Staff Report to the Planning Commission

PSC2024-0002 and PTP2024-0006				
Cambridge Knoll Condominium				
165 and 185 E. Avon Road				
REQUEST	Preliminary One Family Residential Detached Condominium Recommendation and Tree Removal Permit Approval			
APPLICANT	Mark Gesuale Wolverine Building Company 14955 Technology Dr. Shelby Twp., MI 48315			
LOCATION	165 and 185 E. Avon Rd., located on the north side of Avon Rd. and east of Rochester Rd.			
FILE NO.	PSC2024-0002 and PTP2024-0006			
PARCEL NOS.	S. 15-14-351-020 and 15-14-351-058			
ZONING	R-3 One Family Residential District with the MR Mixed Residential Overlay District			
STAFF	Chris McLeod, AICP, Planning Manager

Site Plan

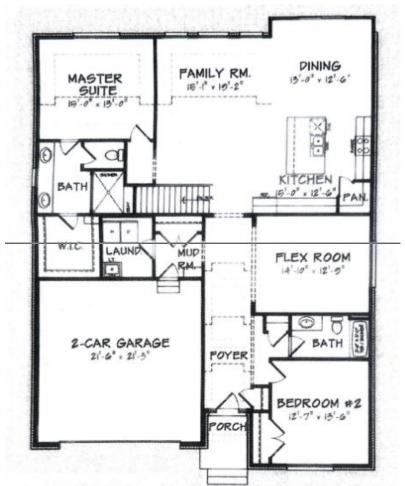
As noted above, the development proposes the use of private roads. The private roads (Cardiff Ct., Arsenal Ct, and Brighton Ct.) are proposed to be 23' in width and will have integrated sidewalks (4 feet wide) on either side, for the full extent of all streets. The roads will be located within a 31' wide private road easement, and therefore utilities that run along the roads will need to be contained within private utility easements rather than the right-of-way. This road cross section is not generally consistent with the City's public road standards and therefore will require engineering approval of the modified configuration. If the roadway configuration is not ultimately accepted by the City, the site will need to be significantly redesigned. Also, it should be noted that the City's latest Streets review has denied the plans. However, the Streets review deals solely with street naming and will not impact the overall layout or design of the development. Therefore, staff has determined this item can be addressed as part of the applicant's Final Condominium submittal and that review process.
